802.3 Ethernet Over SONET Ad Hoc Report

ITU-T SG7 Liaison Communications To IEEE 802

802 Plenary Meeting

March 12, 2001

X.86 Ethernet Encapsulation By LAPS

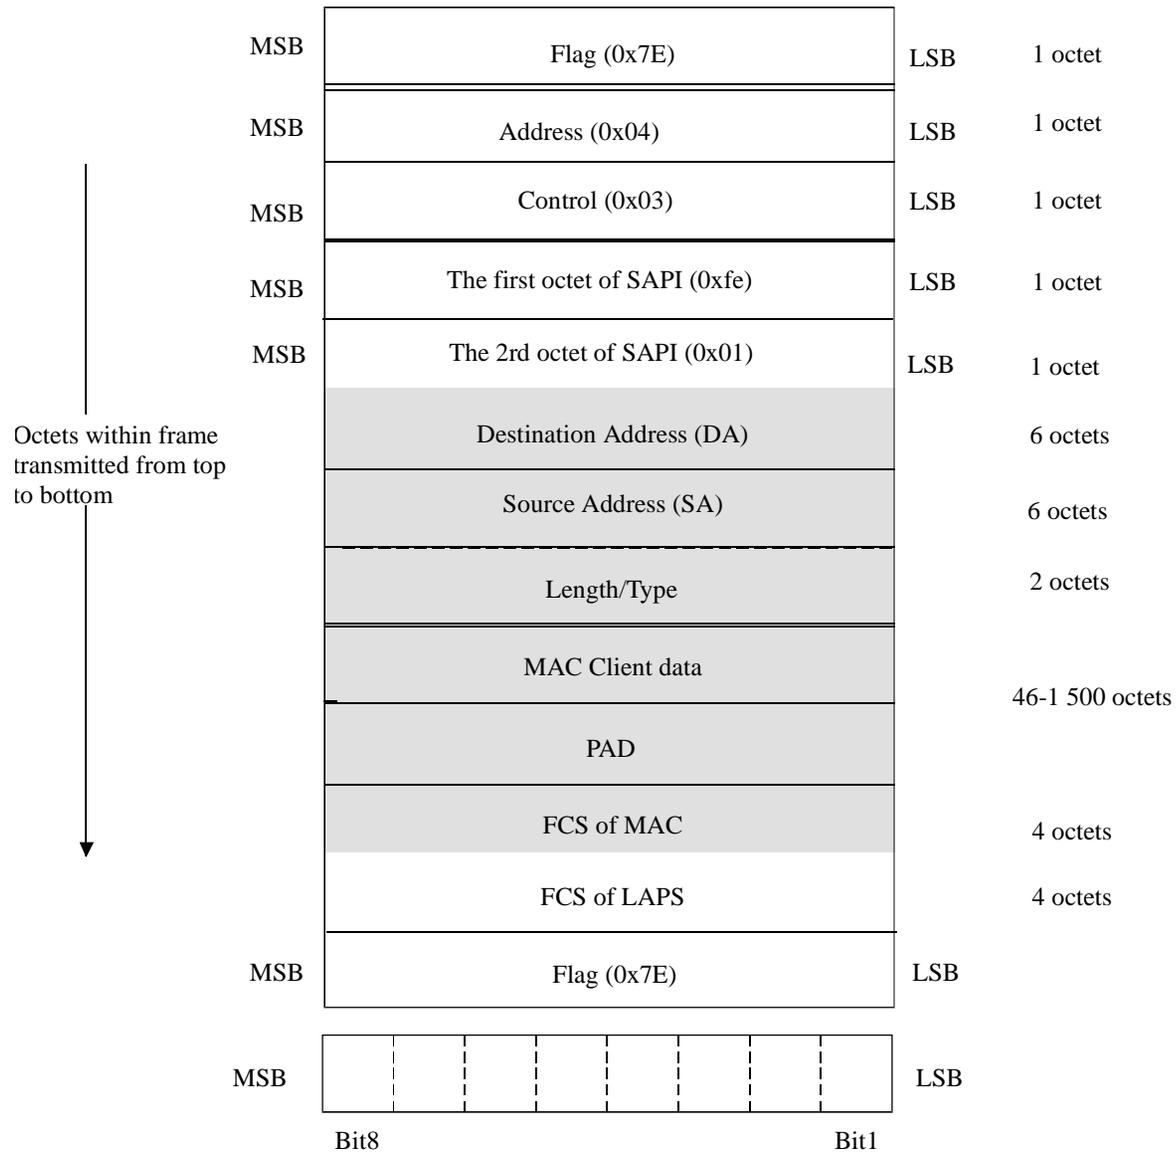
This works well with the initial implementation of 100BaseX into SDH VC-4 (150Mb) by expanding the data transfer rate to match the SDH payload rate. This will not work well with mapping Ethernet frames into lower SDH payload rates, such as 1000BaseX into SDH VC-4.

You describe this as a new PHY for Ethernet. Because X.86 makes changes to the Ethernet frame transfer rate, and uses a store and forward functionality in LAPS, we believe that it is more appropriate to describe this device as a simple 2 port bridge to connect an MII/GMII to a SDH transmission payload.

In addition, in order to provide full functionality for rate adaptation to lower as well as higher payload rates from Ethernet frame transfer rates, we advise that you should consider the addition of 802.3x flow control capability to your Ethernet side interface.”

Recommend a motion to respond to ITU-T SG7 with a request to include 802.3x MAC Control Frames (802.3 Clause 31, Appendix 31A) be used as an alternative Rate Adaptation mechanism specific to mapping Ethernet MAC transfer rates into lower SDH Payload Rates.
